IREDELL COUNTY HEALTH DEPARTMENT

IMPROVEMENT PERMIT / AUTHORIZATION TO CONSTRUCT / OPERATION PERMIT / EXISTING SYSTEM INSPECTION

PERMIT# 122999 PIN# 4638 63 4444 DATE 8-26-04

INITIAL SITE SKETCH Scale 1:100

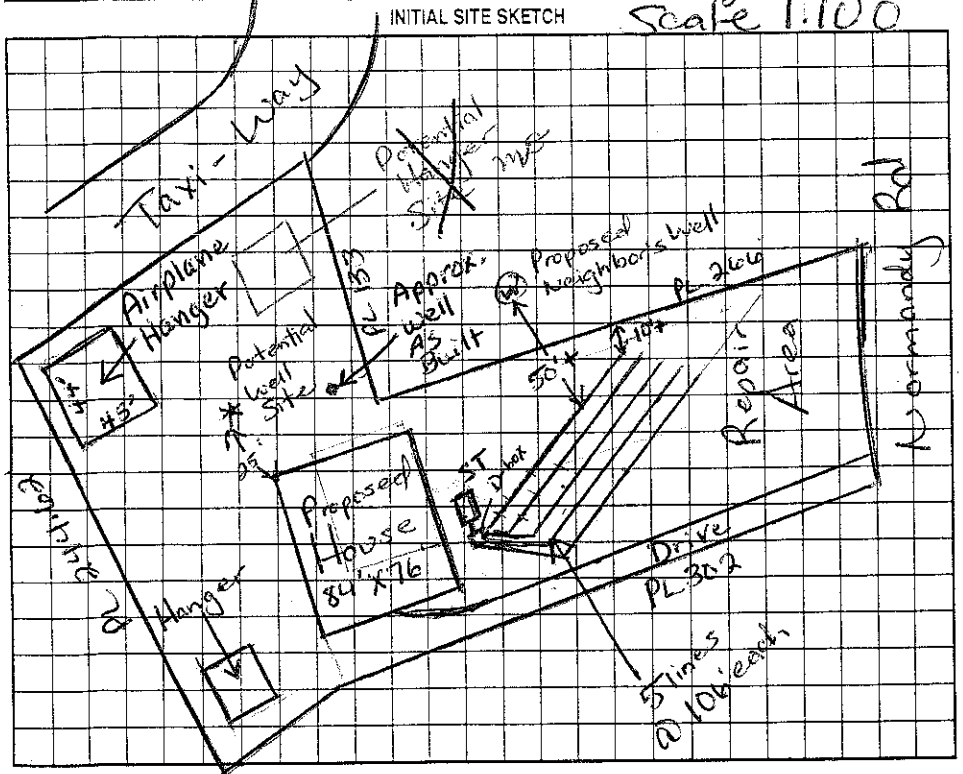
Comments:/Conditions: Keep Septic System at least 10' from PL.
* Best if 25% Reduct. System Installed
* Front Load Garage

Comments:/Conditions: * Keep System Shallow ≤ 24"
Shallow Soils
Keep well 50-100' to Septic System.

AS BUILT SKETCH (NTS)

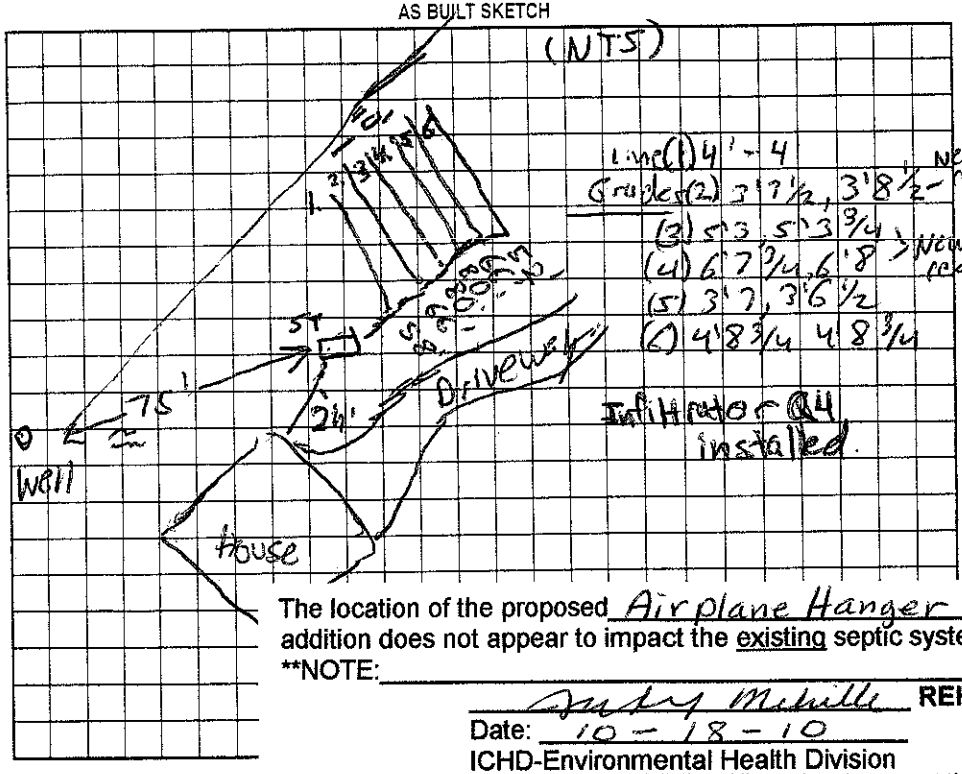
The location of the proposed Airplane Hanger addition does not appear to impact the existing septic system.
